MISCELLANEOUS STEEL LAYOUT
SEQUENCE 20- REF.: 2/S1.42
TRUE PLAN

A	10/04/2022	ISSUED FOR APPROVAL	
REV.	DATE	DESCRIPTION	
REVISION AND ISSUE RECORD			
 A L A M O STRUCTURAL STEEL			
		2784 OLD DALLAS RD. WACO, TEXAS 76705 PHONE: 254 799 2471 FAX: 254 799 6227	
PROJECT WACO HIGH SCHOOL			
CUSTOMER Rogers O'Brien Const Co Inc			
LOCATION 2020 N 42nd St, Waco, TX 76710			
ARCH/ENG O'CONNELL ROBERTSON			
DETAILS MISCELLANEOUS STEEL LAYOUT			
DETAILER HMM		DATE 10/04/2022	JOB NO. 32-22017
CHECKER AJM		DATE 10/04/2022	
PM Dwayne Reed			DRWG. NO. E-2.20.13

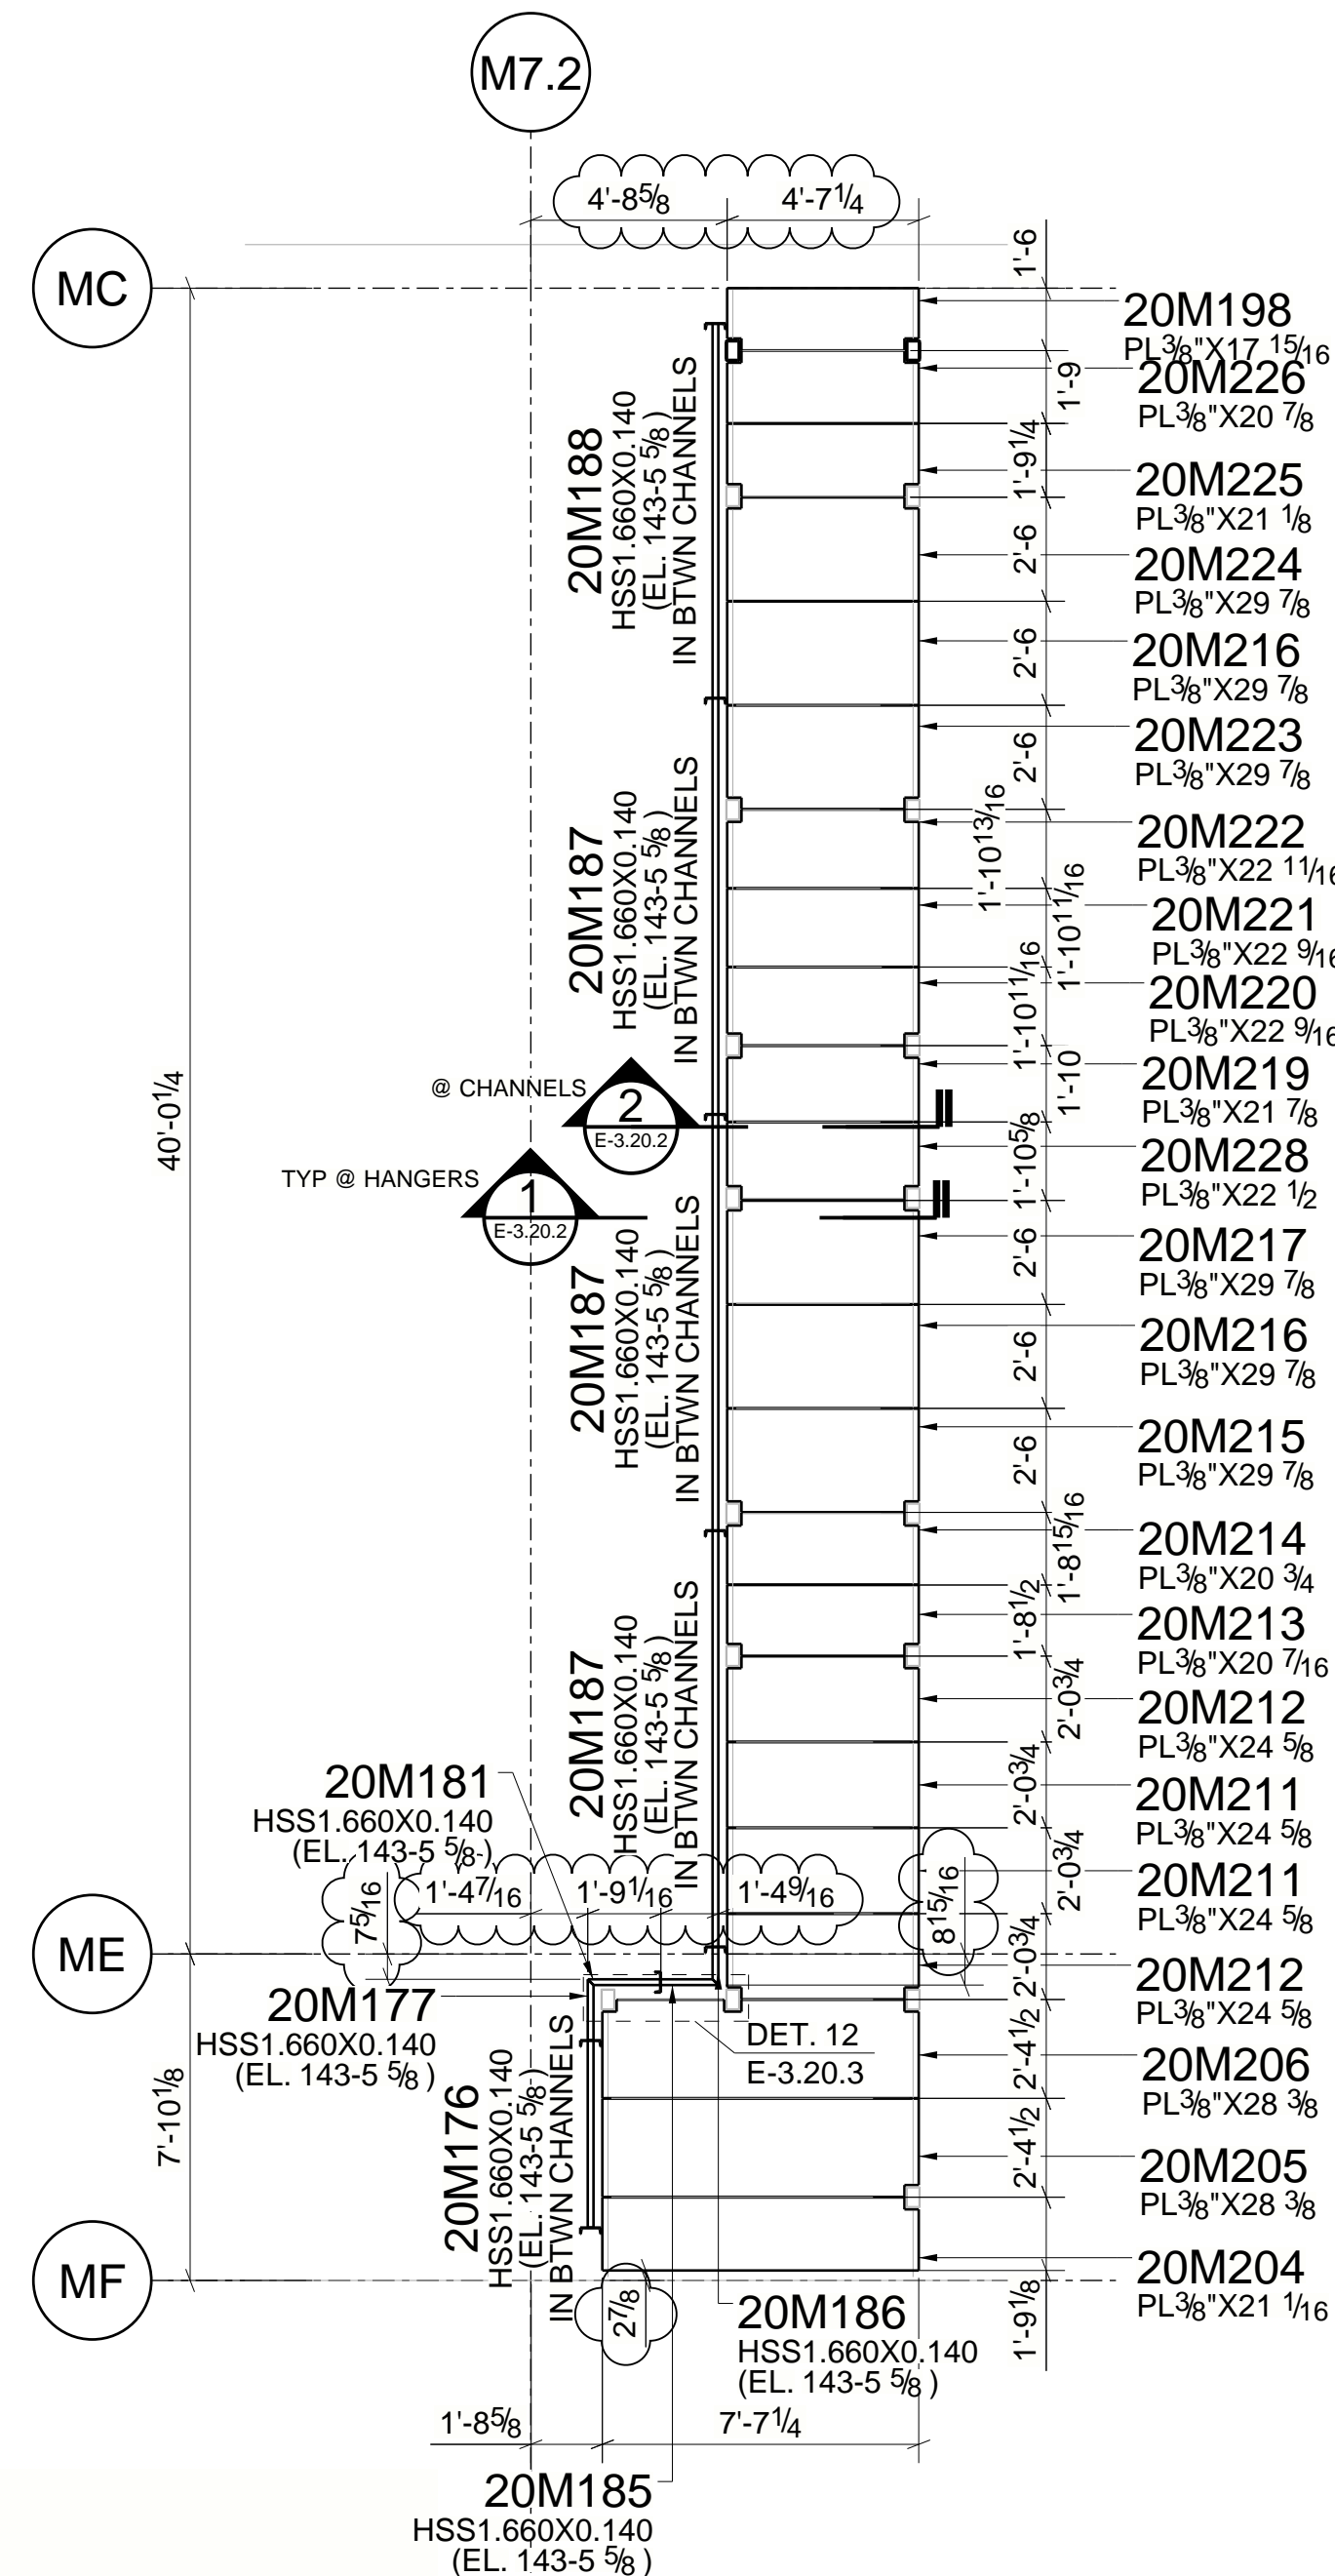
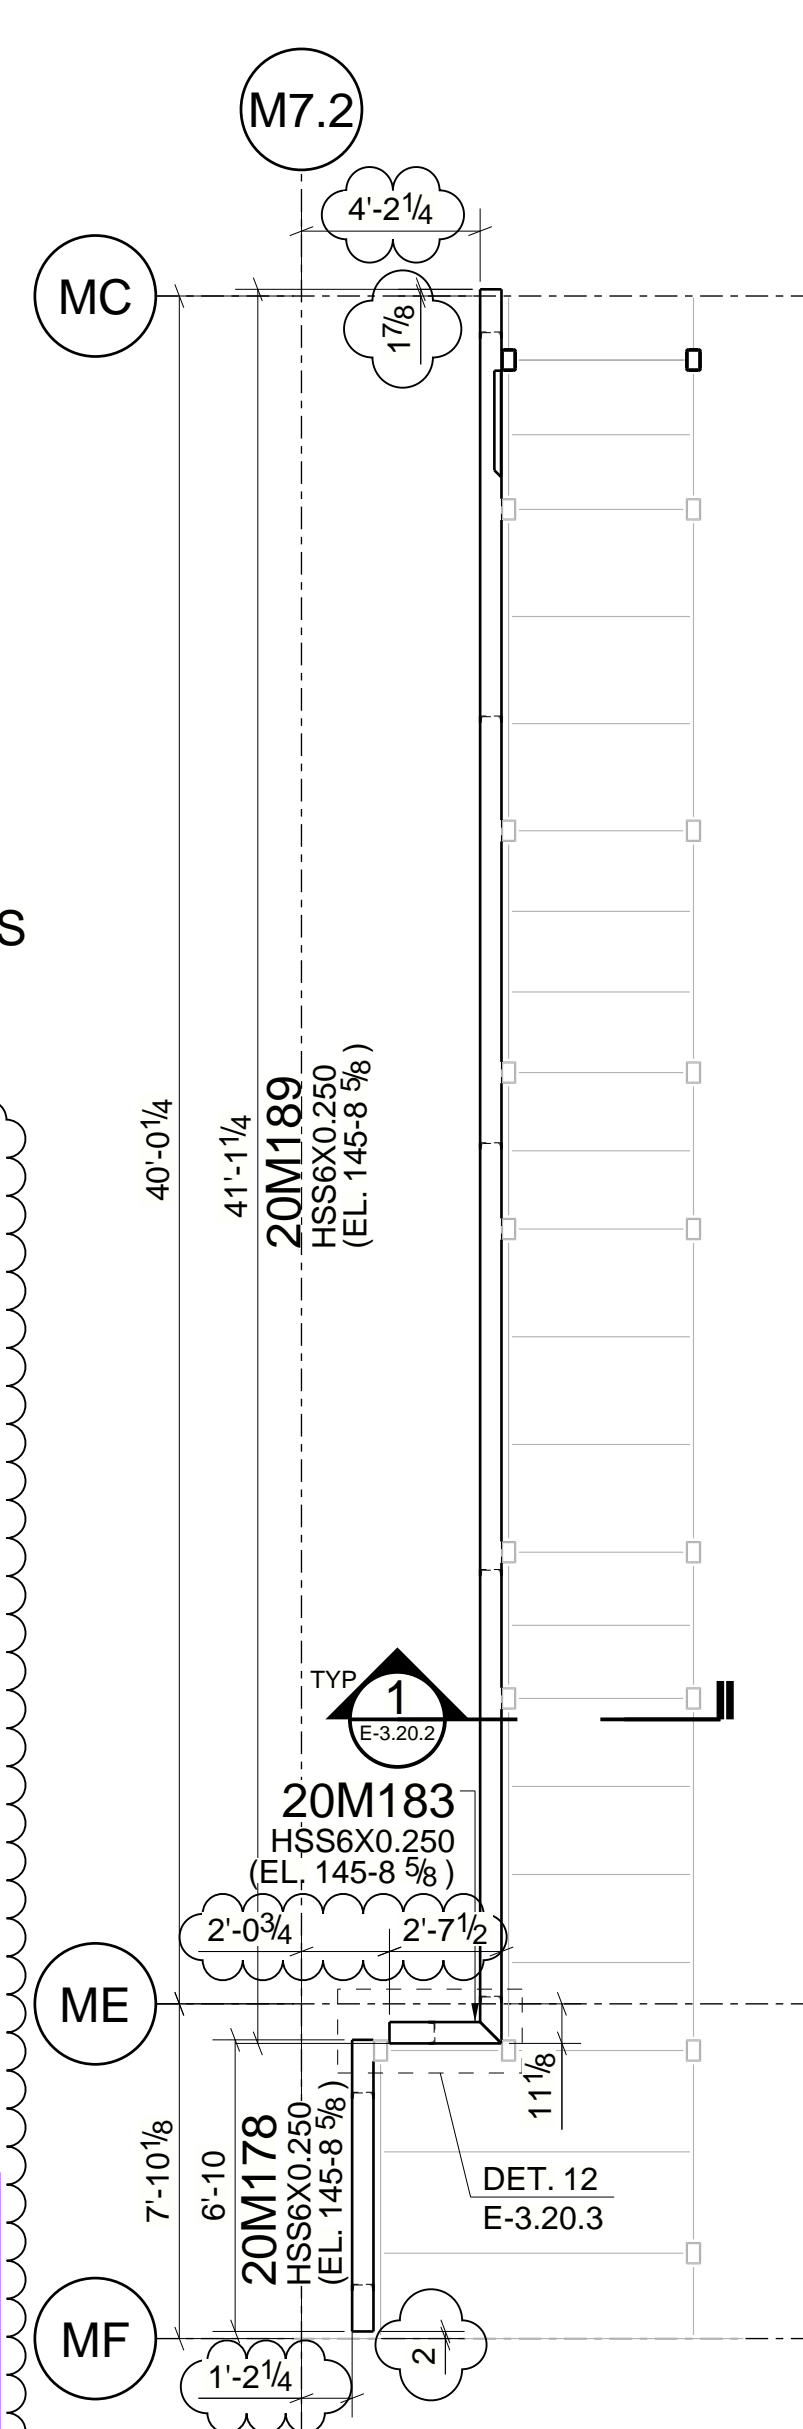
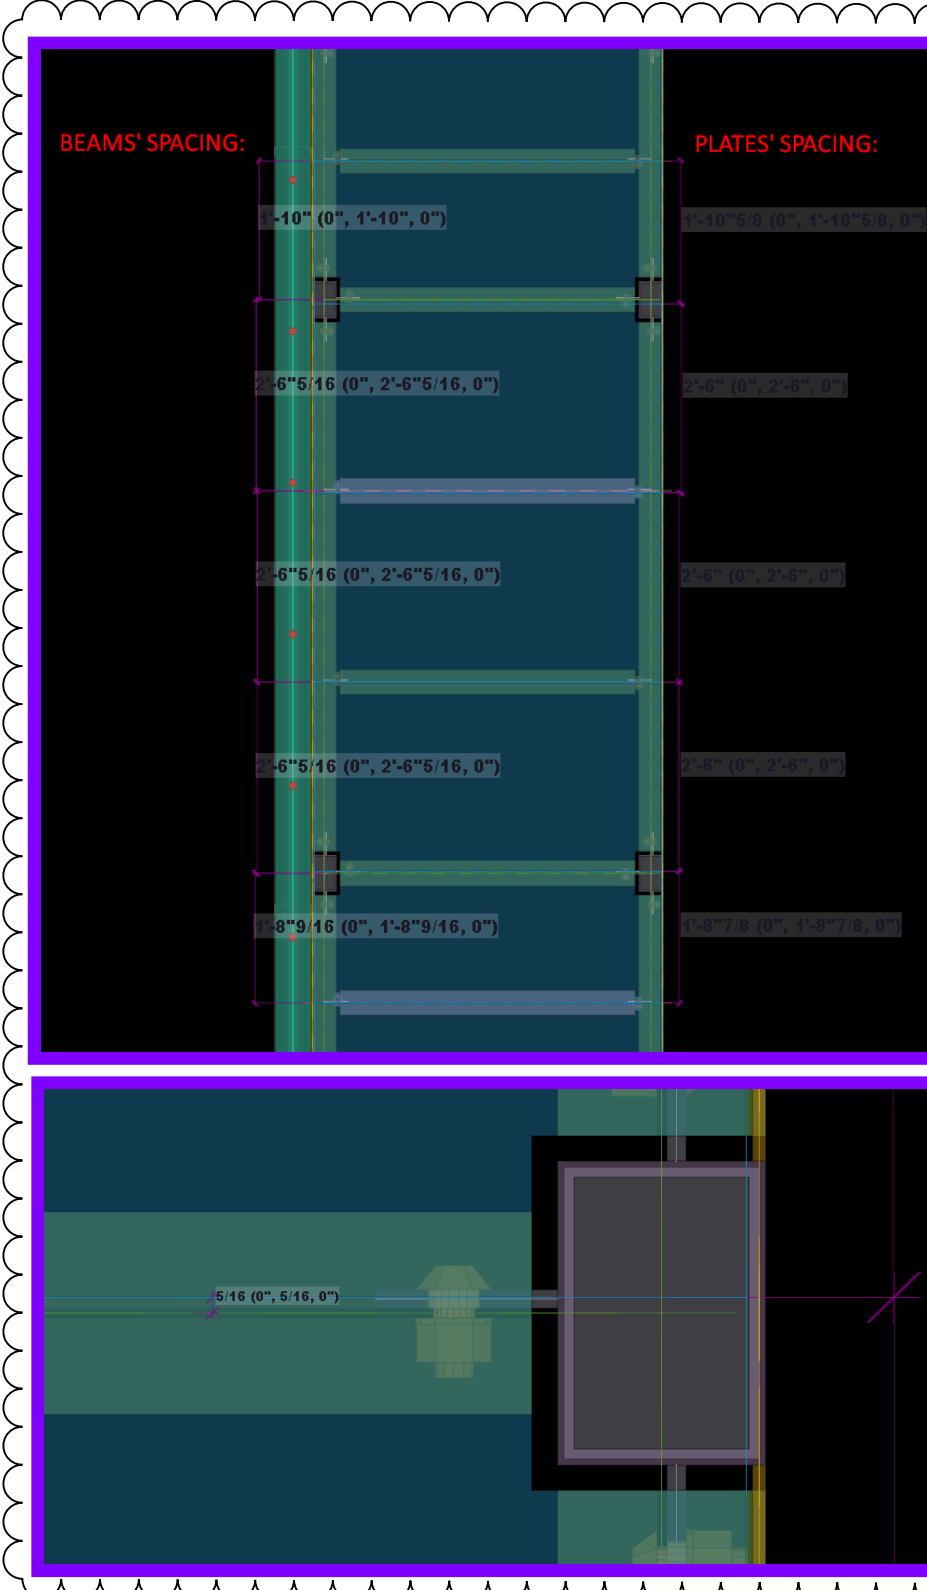
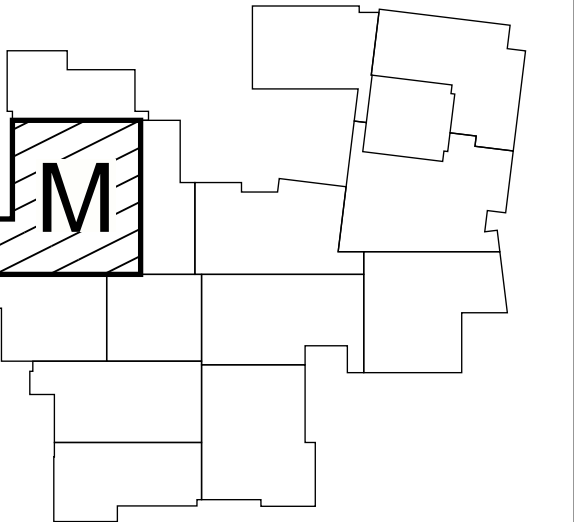
APPROVER PLEASE VERIFY
IF 1/8 GAP BTWN DIAMOND
PLATES IS ACCEPTABLE- TYP

APPROVER PLEASE VERIFY
IF IT IS ACCEPTABLE FOR PLATES'
SPAN TO NOT BE EXACTLY FROM
ONE BEAM'S CL TO ANOTHER IF BEAMS
ARE SPACED JUST A BIT OVER 2-6.
SEE ALSO SNIPPET FROM MODEL
BELOW:

APPROVER PLEASE VERIFY
ALL CLOUDED DIMENSIONS
